Report: TAB PRACTICE

Function: Test, Adjust, & Balance

07-14-25 FREDDY'S DENTON, TX

Project: 07-14-25 FREDDY'S DENTON, TX

Asset: DOAS1

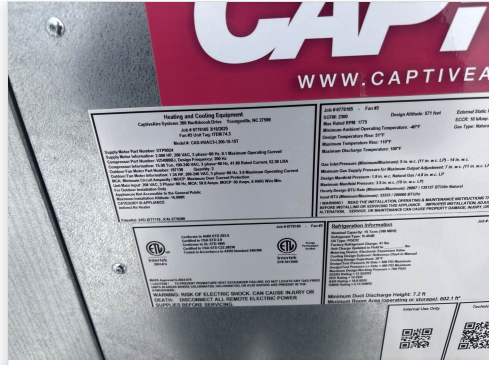
The diffuser total equates to more than schedule design. Unit was balanced proportionally to balance schedule.
